ENGINEER'S SUPPLEMENTAL INSTRUCTIONS NO. SIXTEEN (16)
(Via Posting to FTP Site and Electronic Mail)

RE: Harold D. Thompson Regional Water Reclamation Facility (HDTRWRF)-Phase 1
ENGINEER'S SUPPLEMENTAL INSTRUCTIONS NO. SIXTEEN (ESI-016)

This ESI-016 is being issued to provide additional information on underslab piping to the wet wells of the Pumping and Disinfection Building. The previously issued Drain and Vent Plan, Sheet PD-17, has been revised to include additional information on the A-Basin Drain pipe and the Headworks Wastewater/Drain pipe coming into the wet wells. The information given on this drawing will allow construction of the pipelines to 5 feet outside of the building foundation. Please note that pressure testing of these pipelines will be required and must be incorporated into the construction schedule.

AERATION BASIN LEVEL CONTROL STRUCTURE
HAROLD D. THOMPSON REGIONAL WATER RECLAMATION FACILITY
LOWER FOUNTAIN METROPOLITAN SEWAGE DISPOSAL DISTRICT

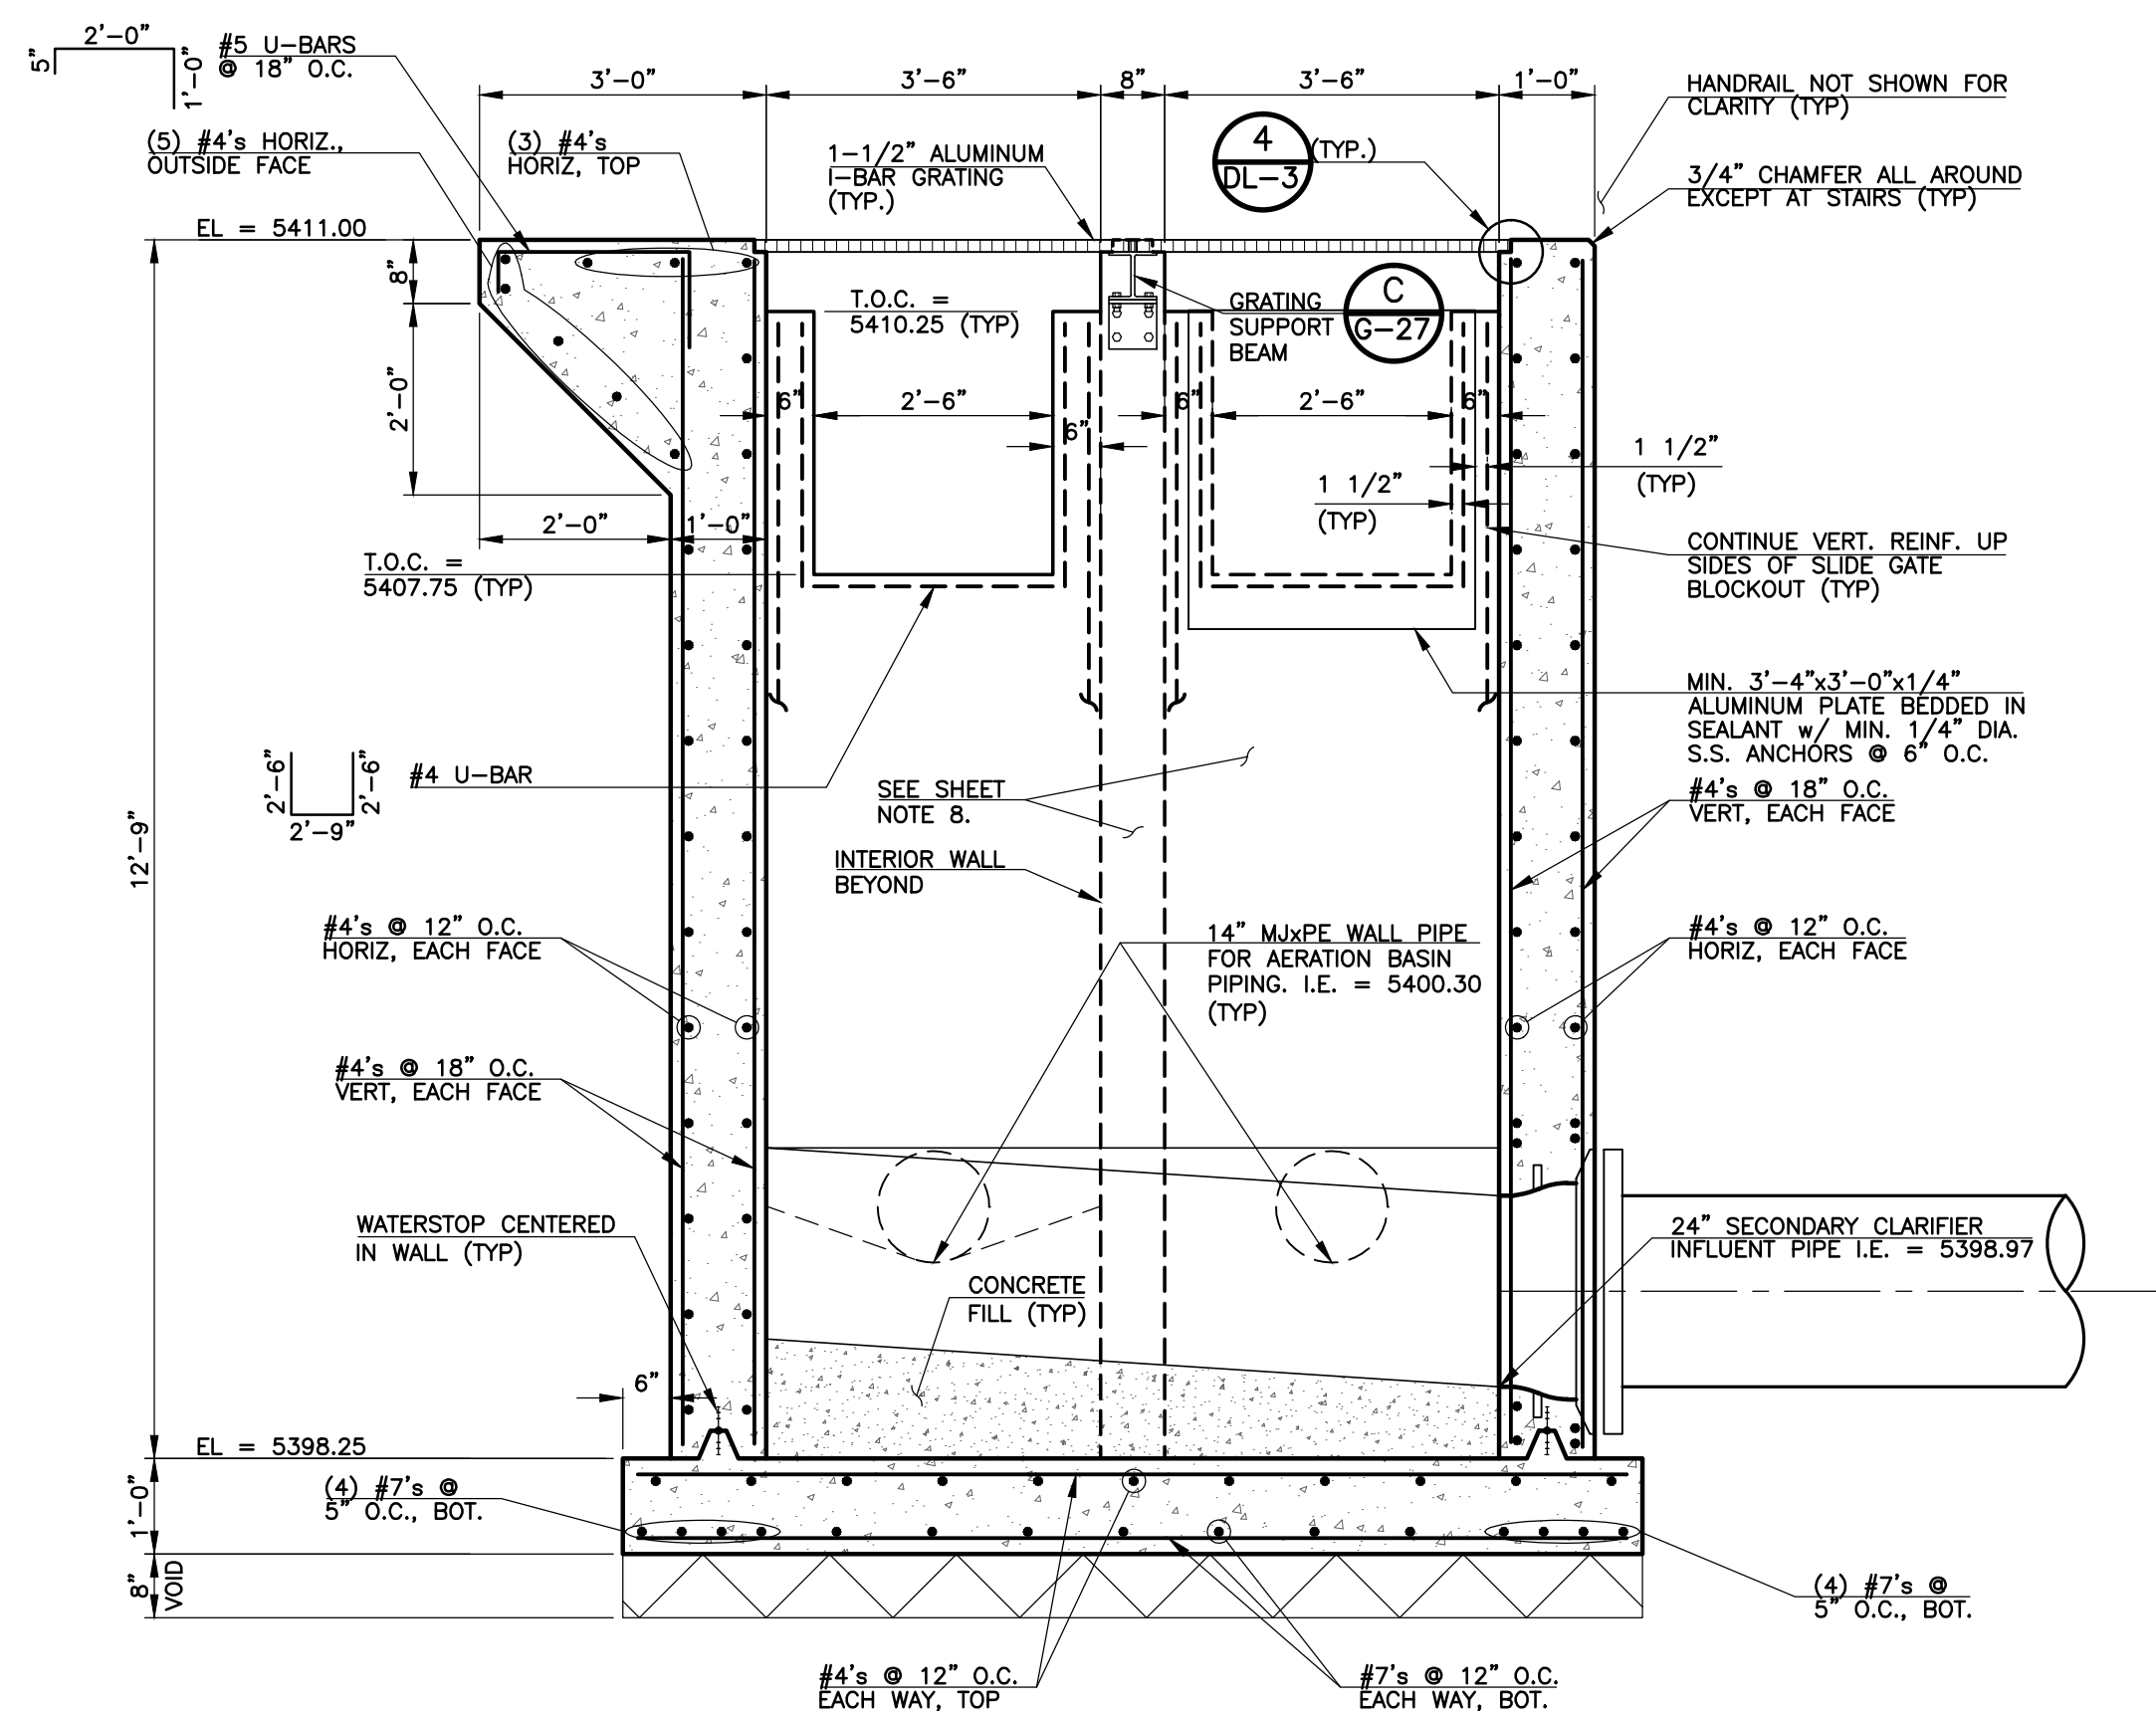
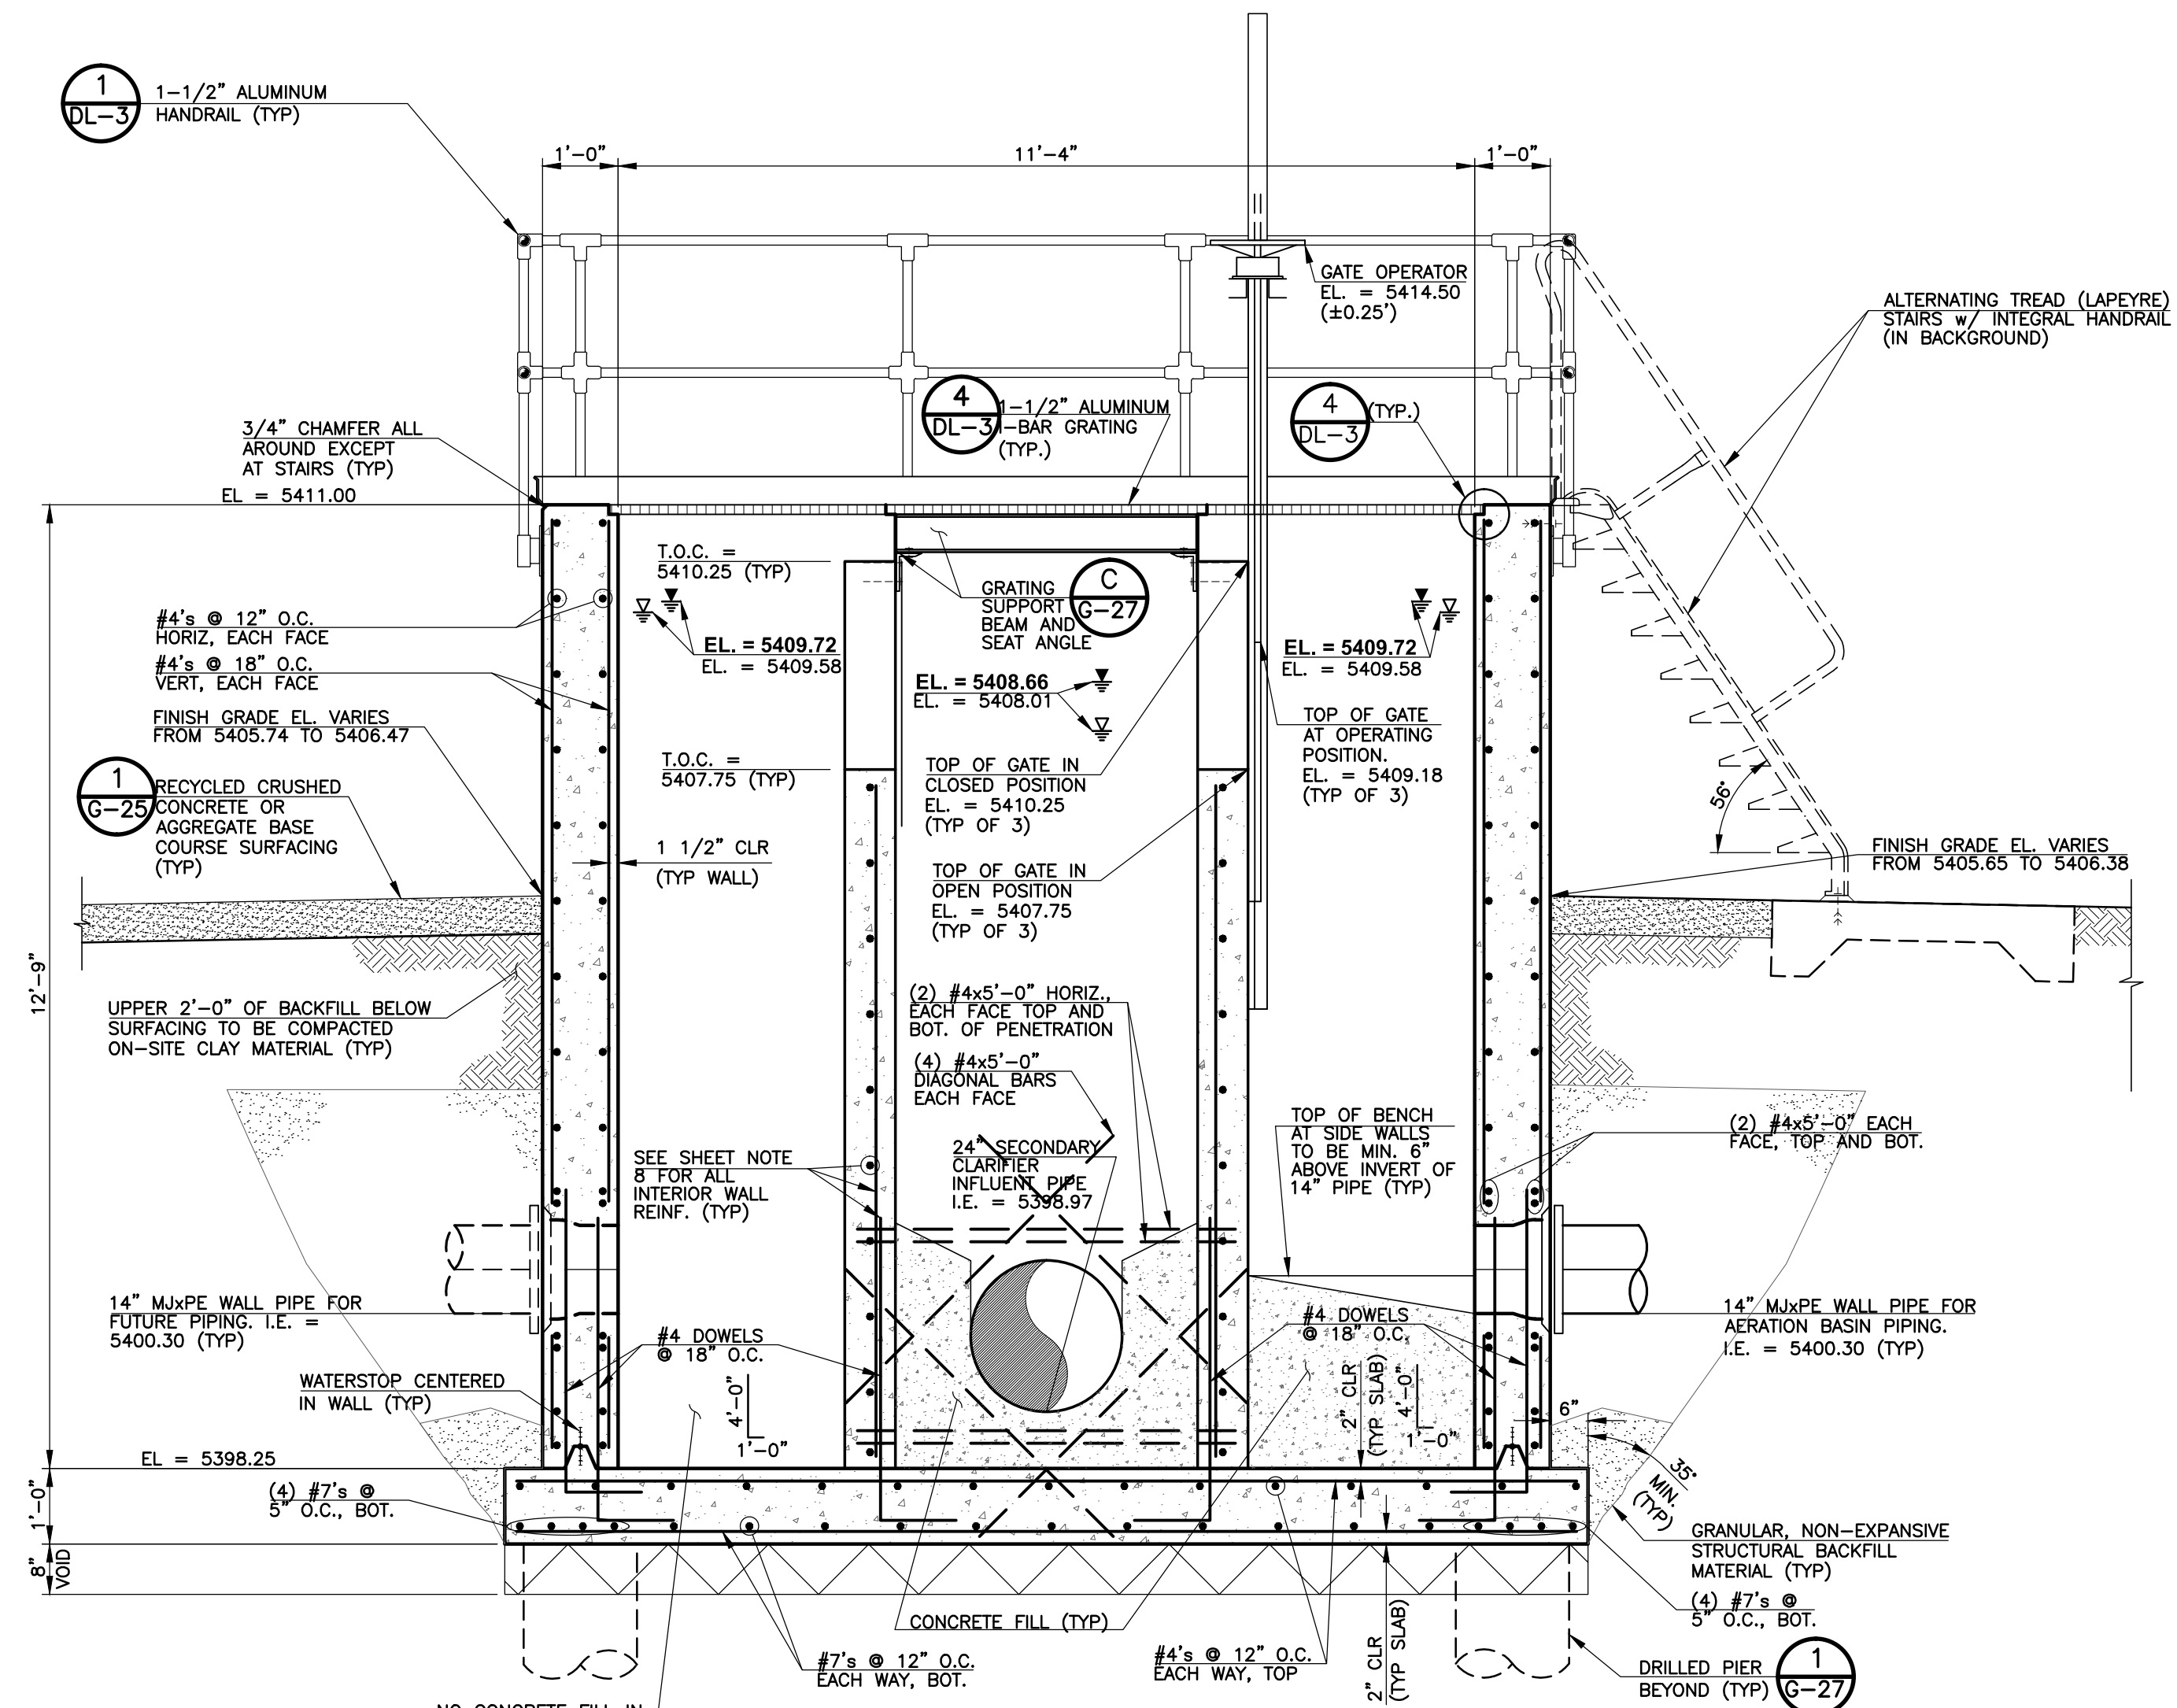
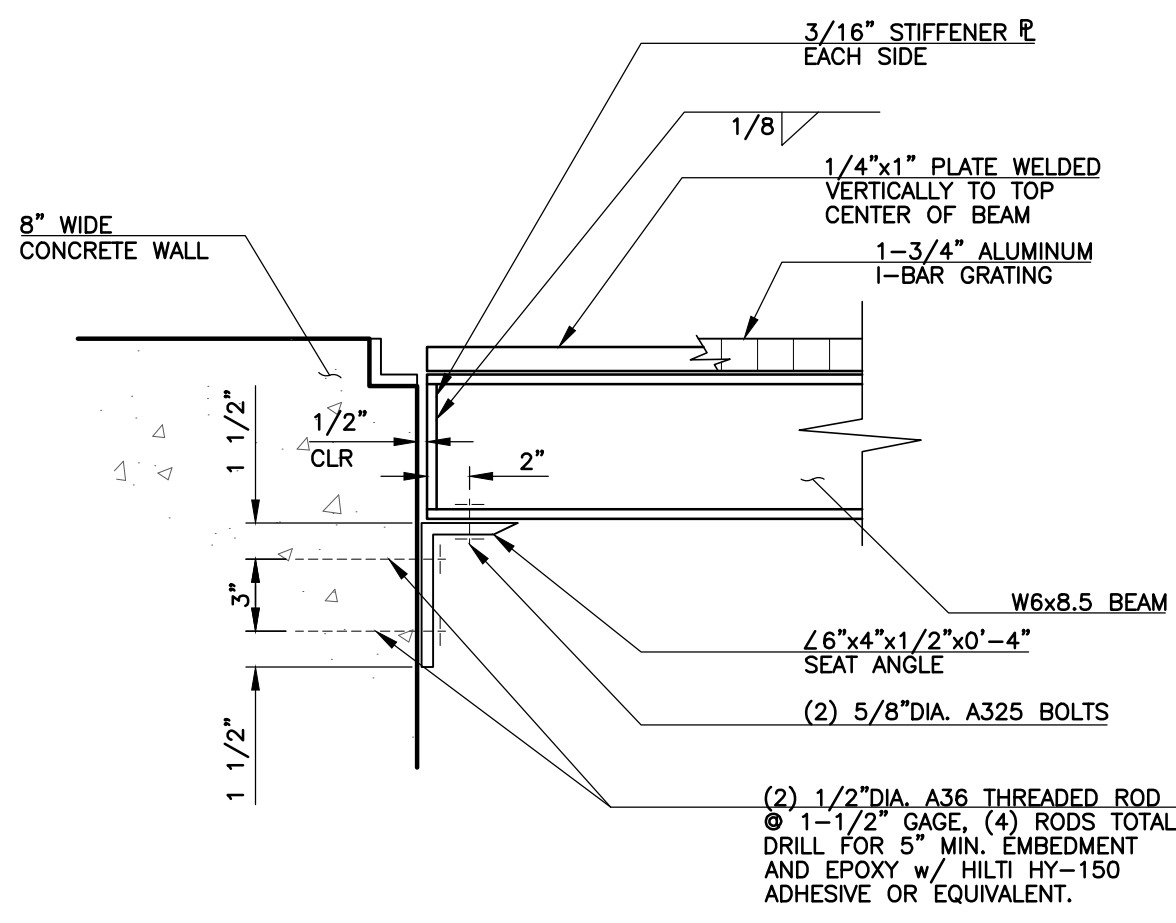
This ESI-016 also includes an in-progress drawing for the Aeration Basin level control structure, Sheet G-27. This in-progress drawing is being issued for drilled pier construction data only. All other information is considered in-progress information and is not to be used for construction. However, it is requested that WCMI prepare a Request for Contract Modification Order (RFCMO) for this structure based on the attached Sheet G-27. For construction layout of the drilled piers associated with this structure, a revised Sheet G-3 – Coordinate Lists II is attached as well.
